TO: Planning and Zoning Commission
FROM: Bethany Ross, *Planner*
DATE: February 25, 2025
SUBJECT: SP2025-005; *Site Plan for 2651 Sunset Ridge Drive*

PROJECT NUMBER: SP2025-005
PROJECT NAME: Site Plan for 2651 Sunset Ridge
SITE ADDRESS/LOCATIONS: 2651 SUNSET RIDGE DR

02/19/2025: SP2025-005; Site Plan for 2651 Sunset Ridge Drive

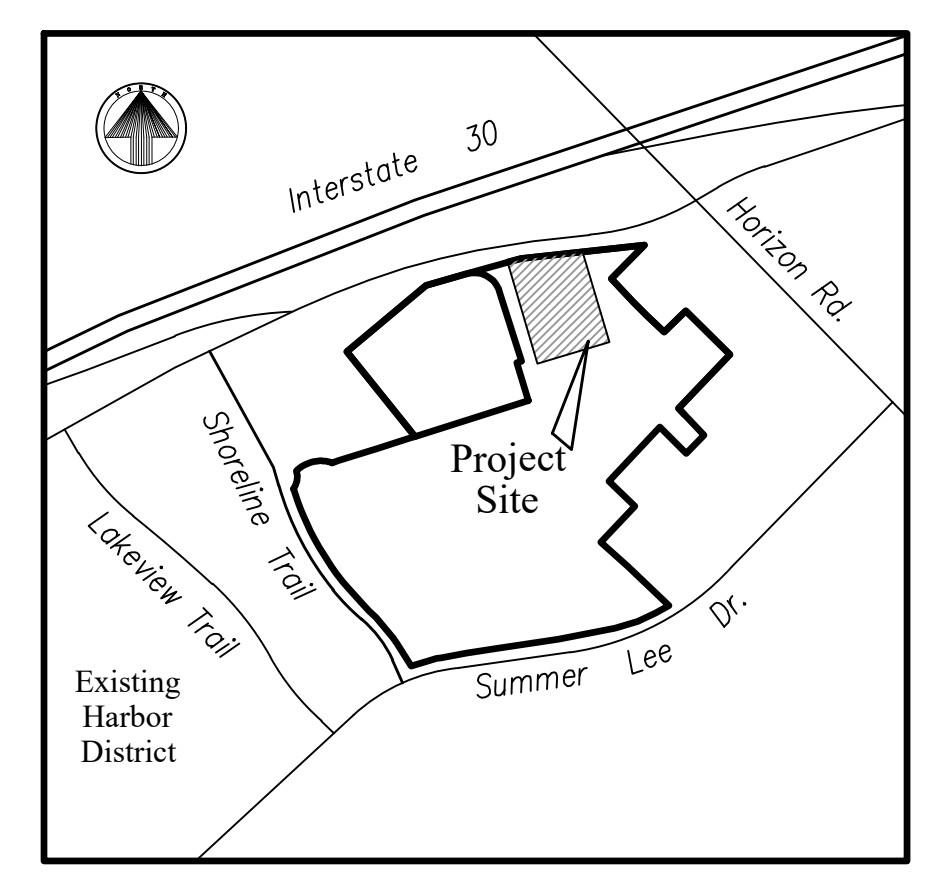
General Items:
 - Must meet City 2023 Standards of Design and Construction
 - 4% Engineering Inspection Fees
 - Impact Fees (Water, Sewer, Roadway).
 - Need to resubmit engineering for review due to expiration of engineering plans.
 - Move light pole along Sunset 4' from back of curb

SITE LIGHTING PHOTOMETRIC PLAN

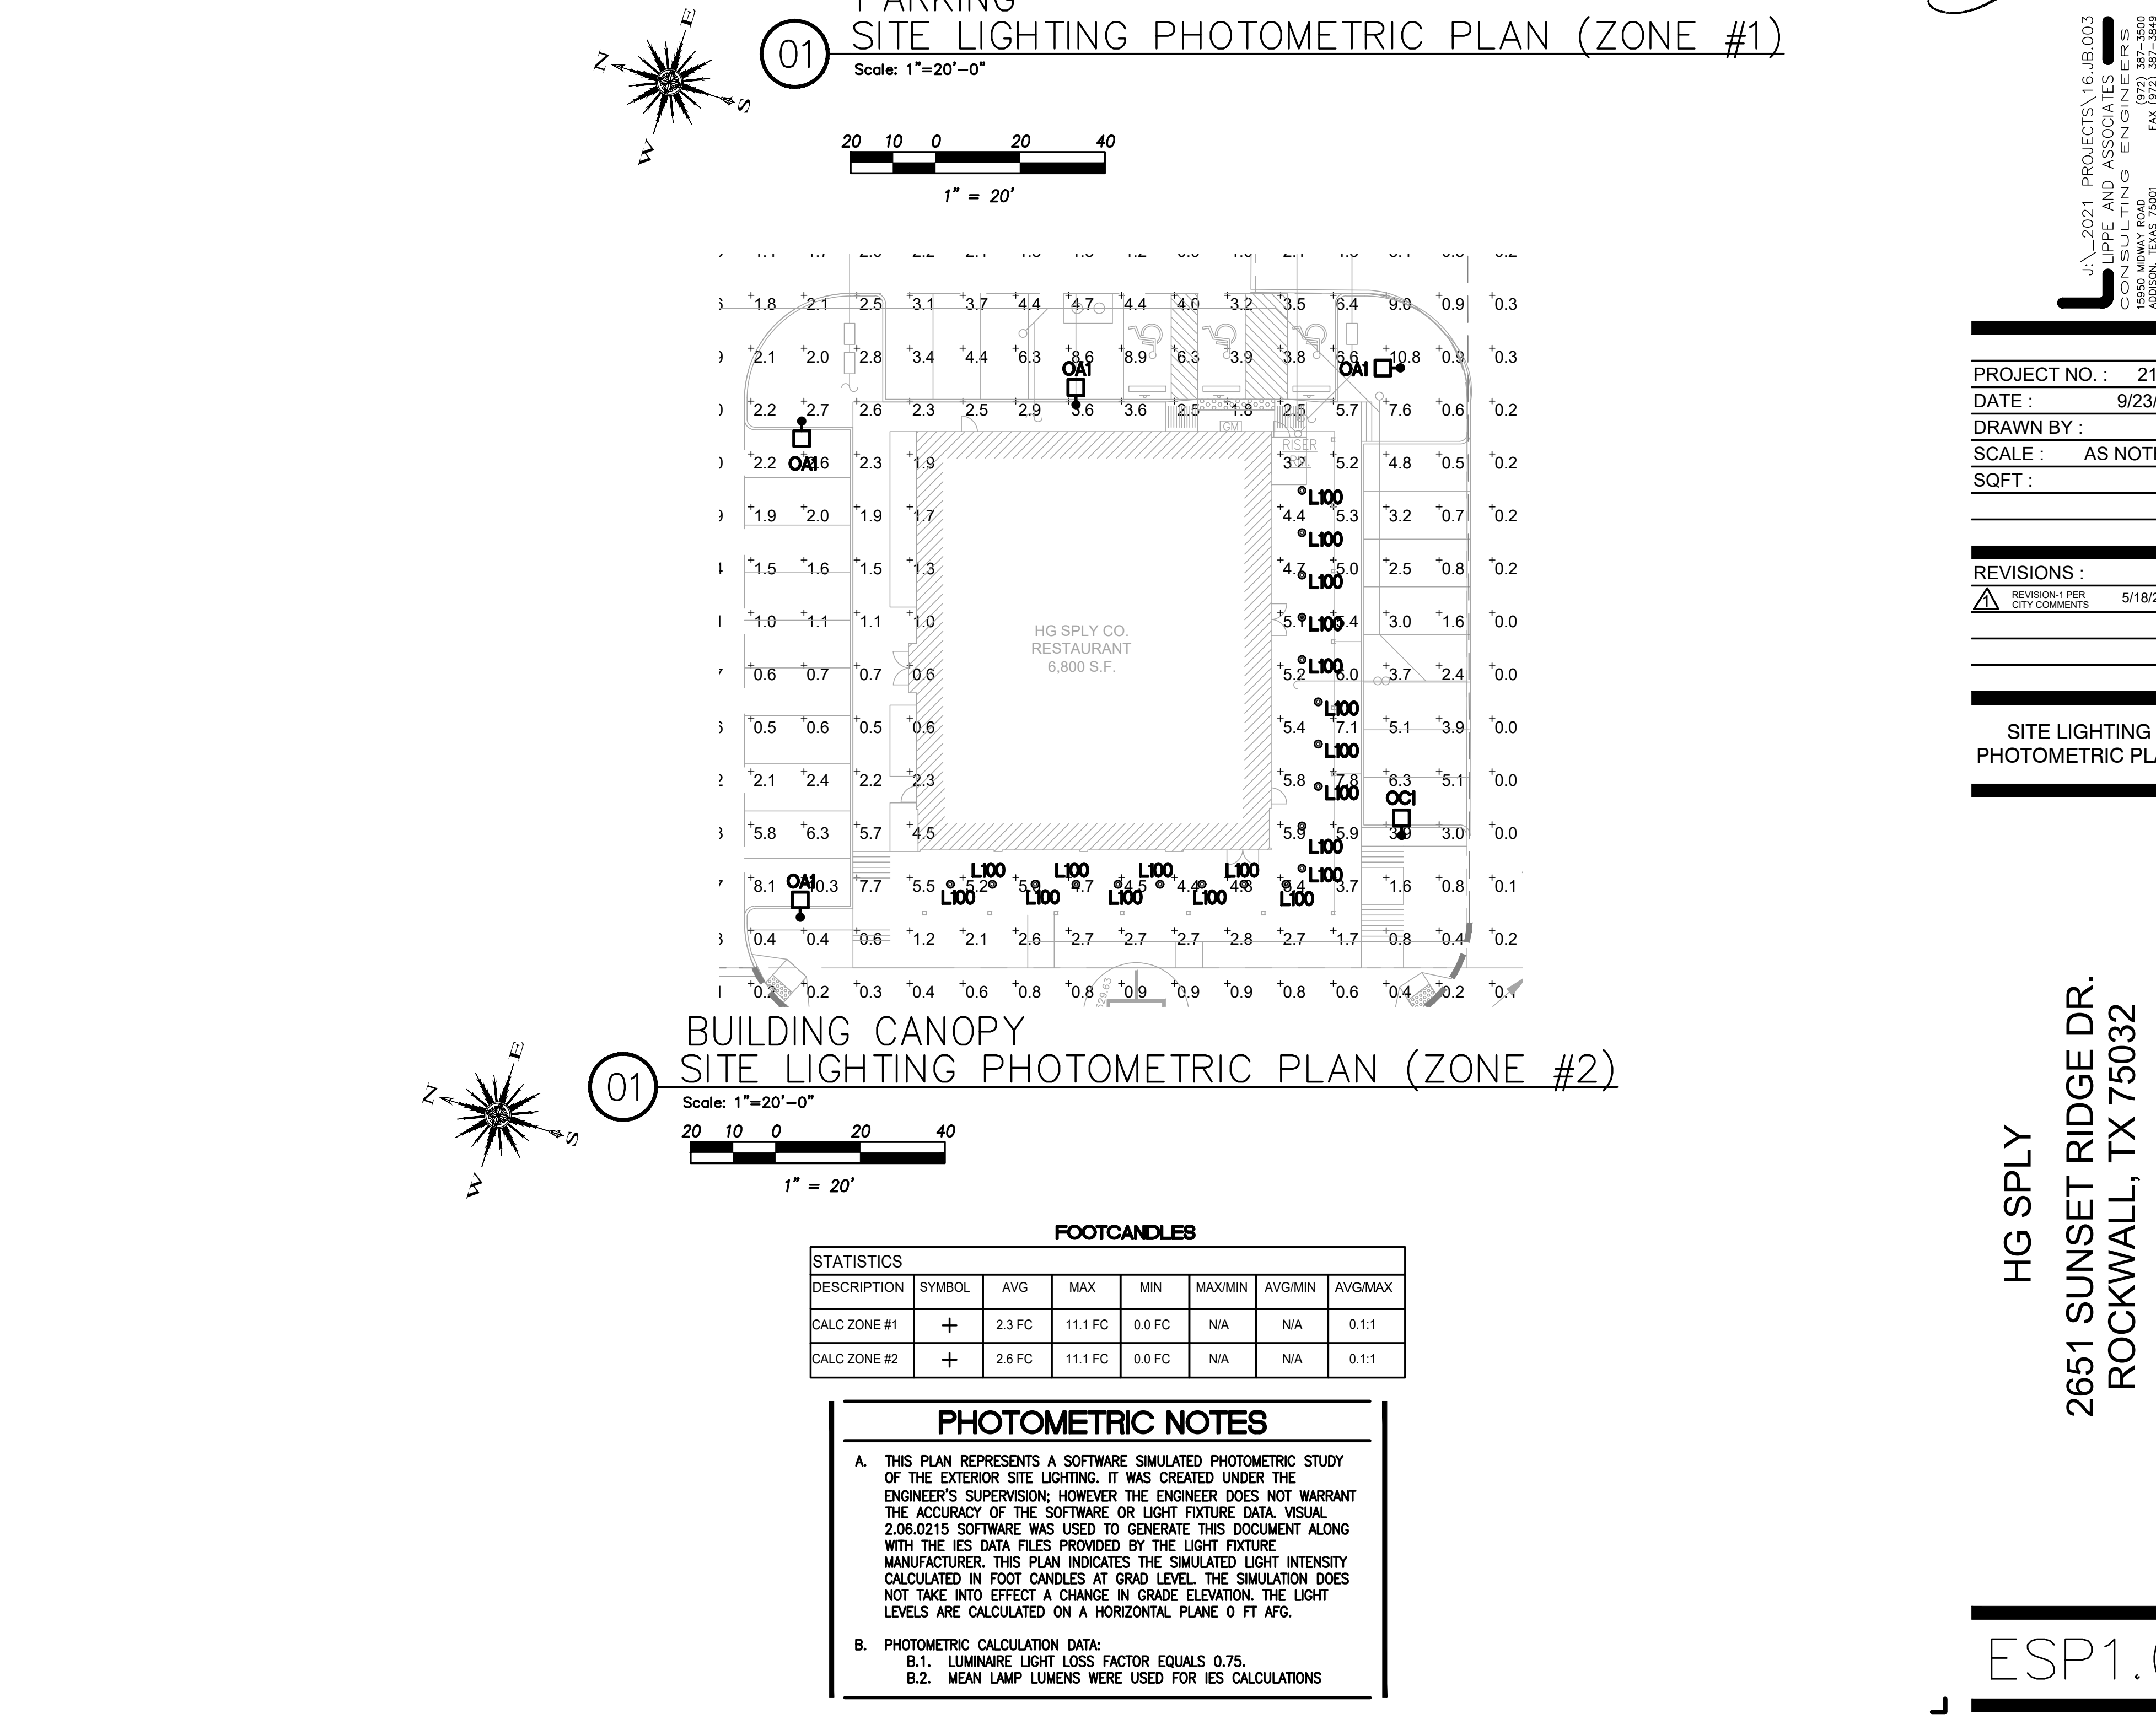
M.6 Photometric Plan. Please provide a photometric plan that meets the requirements of the UDC. The allowable maximum light intensity measured at the property line of any non-residentially zoned lot shall be 0.2 of one (1) footcandle or 0.2 FC.
